ADDENDUM 01

RE: Palmer Courthouse Generator Addition

FROM:
Alaska Court System
820 West 4th Avenue
Anchorage, Alaska 99501
Eddie Hebert, Project Manager
(907.264.8284)

PREPARED BY:
MCG Explore Design
421 W First Ave, Ste 300
Anchorage, Alaska 99501
(907.563.8474)

SECTION
 80.28
 DETAIL
 80-63

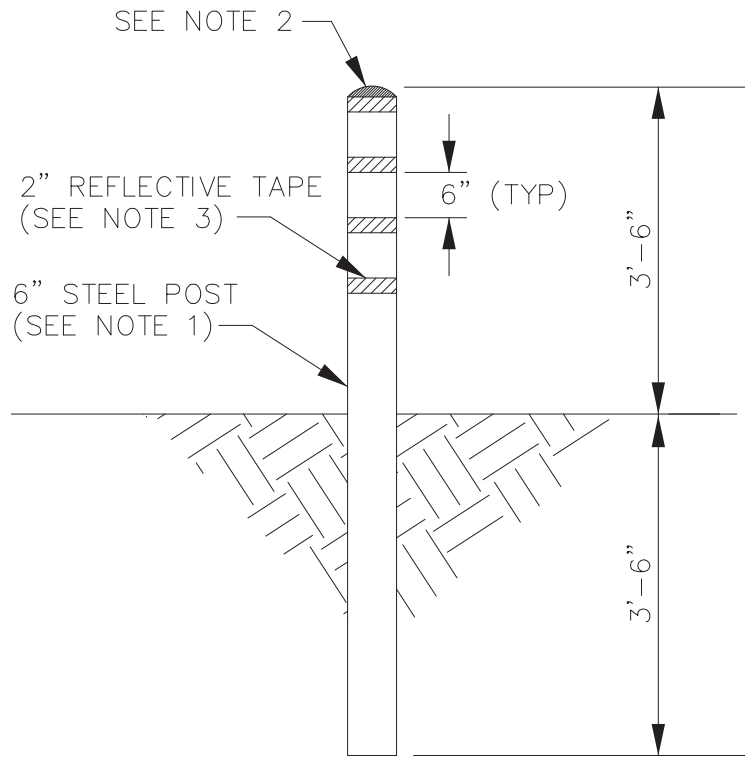
9. Question: *Please provide detail or more information to find the "F&I Protective Post IAW City of Palmer Standard Detail 80-63" called out for the Generator Site Plan detail 1/C100.*

Response: See attached referenced detail. Additionally, the City of Palmer Specifications can be downloaded here: [Standard Specifications and Development Standards | Palmer, AK \(palmerak.org\)](https://www.palmerak.org/standards)
